Bank Stability Procedures  
Pipeline Water Crossings

Roberto Landazuri  
ExxonMobil Pipeline Company

October 10, 2023

30113936 Task 1.5

Figure 3. Crossing US-00145 is an Elevated Pipeline

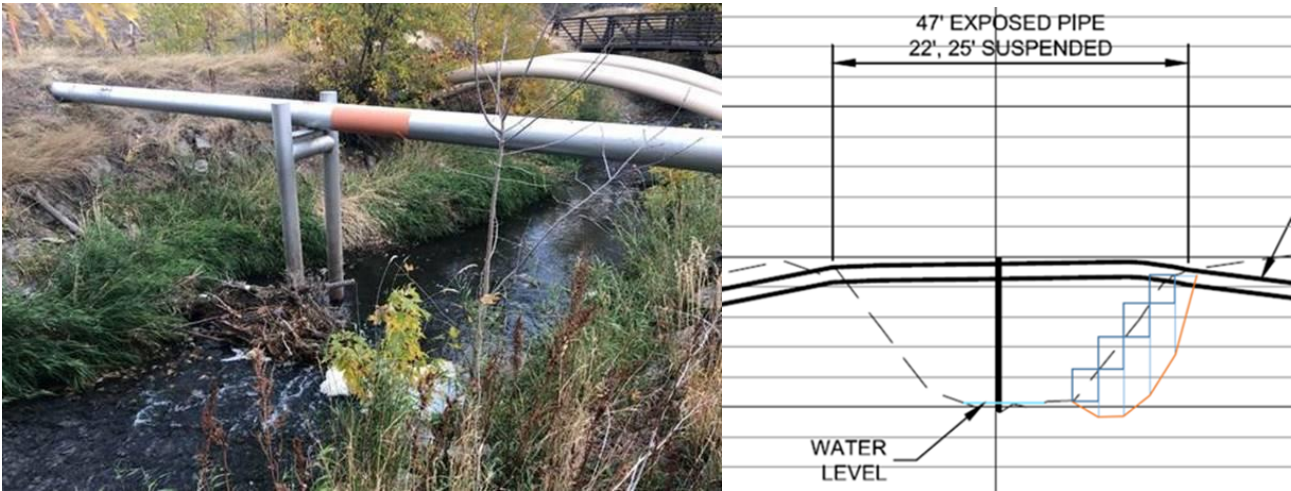
Figure 3 shows US-00145 as an example of a crossing with an elevated pipeline where soil spring analysis is not needed due to minimal soil load. The length of pipeline effected by the failure plane used in the bank stability assessment is small and it would be better to use the bank erosion rate from the hydrotechnical assessment to evaluate the expected amount of time before the allowable USL may be reached.
